TO: DEVELOPMENT REVIEW BOARD
FROM: CURRENT PLANNING SERVICES
SUBJECT: CASE 121-DR-1995#5
REQUEST: Approve site plan & elevations for condominium project
PROJECT NAME: Mirage Trail
LOCATION: East of Legend Trails Parkway, between Desert Ridge & Roadrunner Drives

Mirage Trail Condominiums at Legend Trail, Parcel D, Phase 2

Development Review for a 36 unit condominium Project

Architectural Site Plan

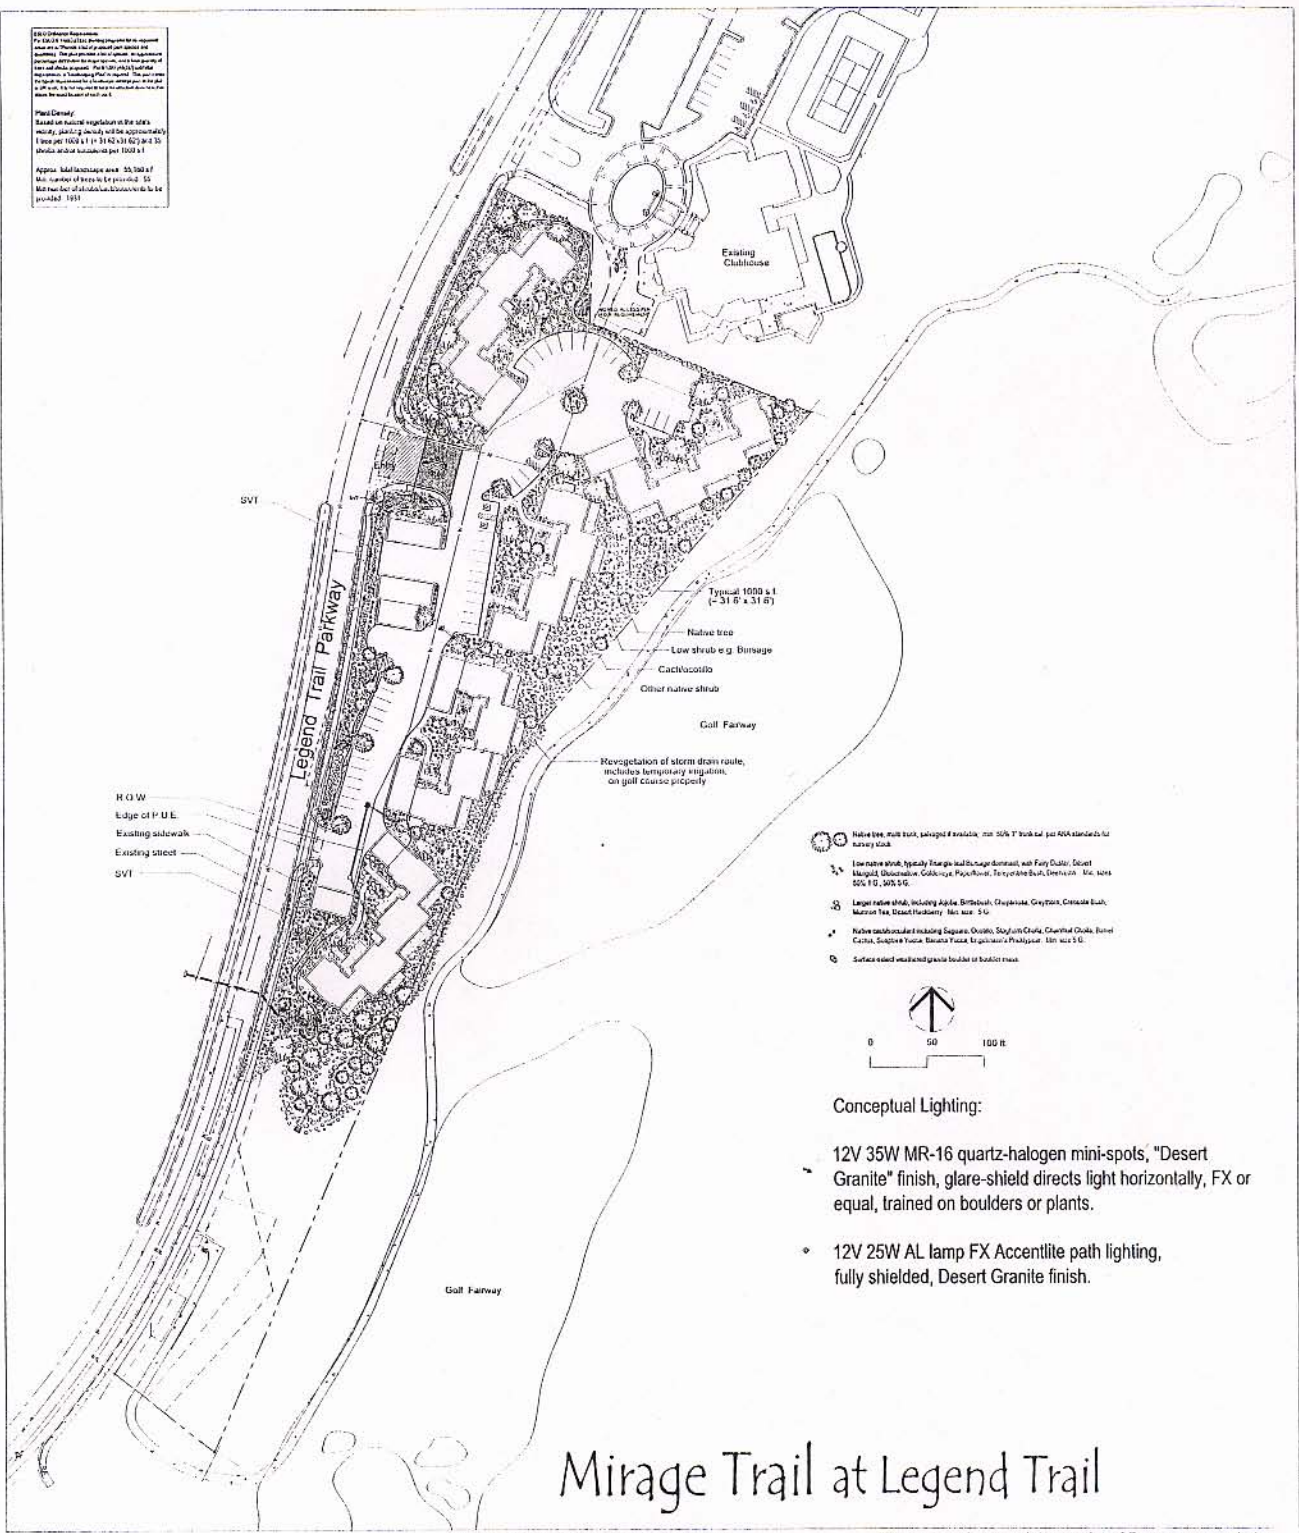
- b. The location and configuration of all site improvements shall be constructed to be consistent with the Architectural site plan submitted by Mirage Homes with a date of November 3rd 2003.

Illustrative Site Plan, Landscape & Lighting Concept Plan

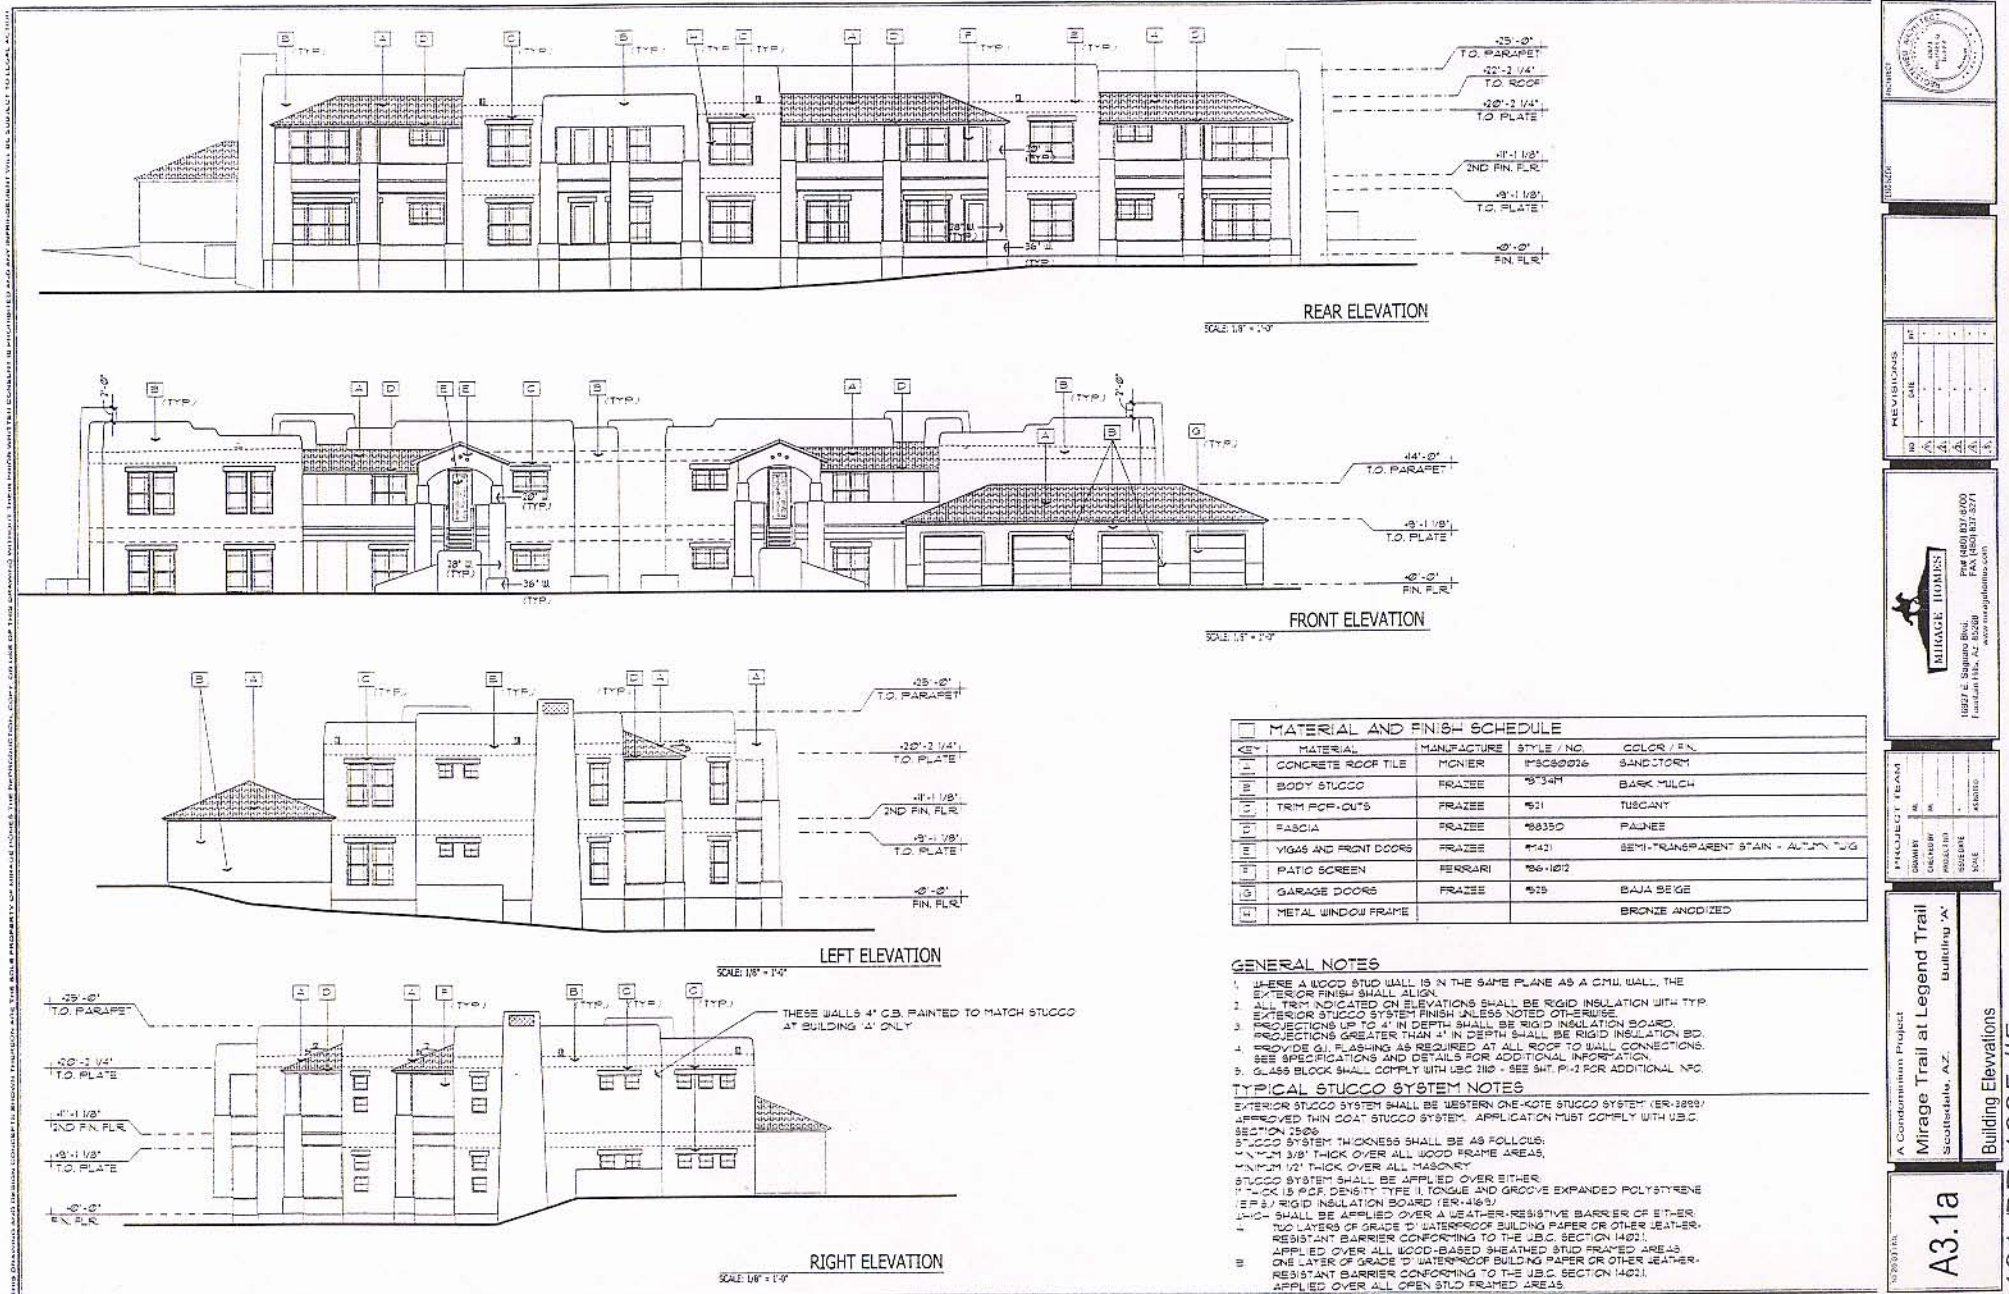
- c. Landscaping, including quantity, size, and location of materials shall be installed to be consistent with the Illustrative Site Plan, Landscape and Lighting Concept Plan submitted by LVA Urban Design Studio, LLC with a date of October 21, 2003.

PROJECT: A3.1a

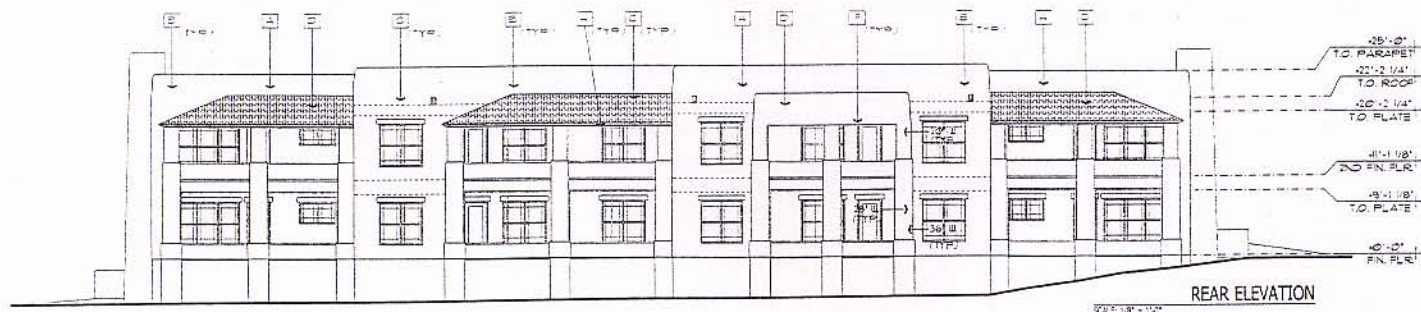
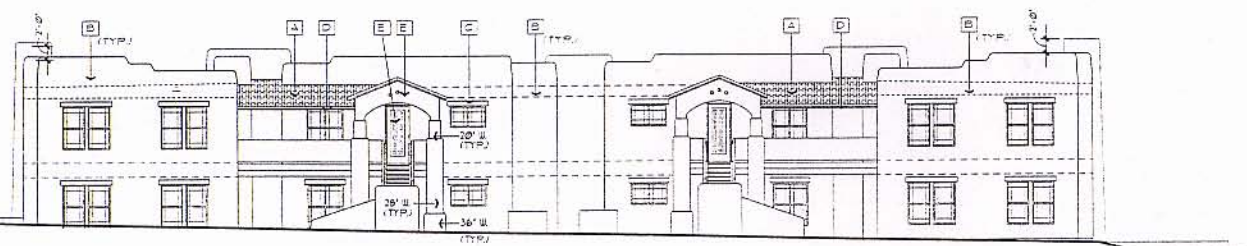
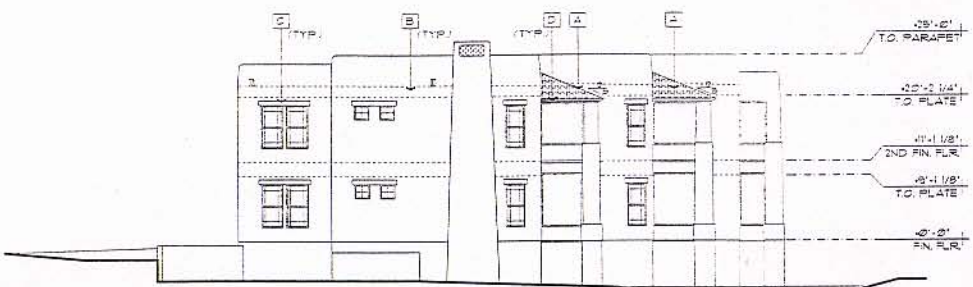
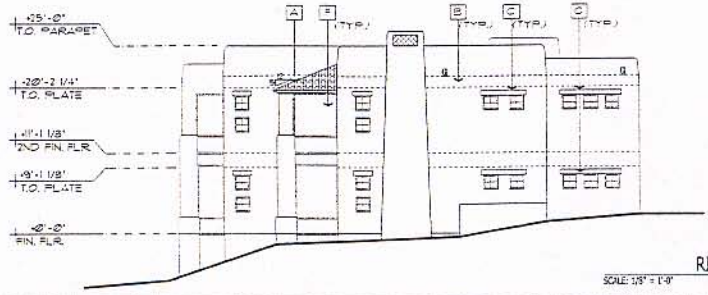
- a. Architectural elements, including dimensions, materials, form, color, and texture, shall be constructed to be consistent with the building elevations submitted by Mirage Homes with dates of September 8, 2003 (Sheet A3.1b), September 10, 2003 (Sheet A6.1), October 8, 2003 (Sheet A3.1e) and October 20, 2003 (Sheets A3.1a, A3.1c and A3.1d).

- A. Paint colors, specifically the garage doors, body stucco and patio screens, shall be revised so that they do not exceed light reflective values (LRV) of 40 percent and a chroma of six (6).
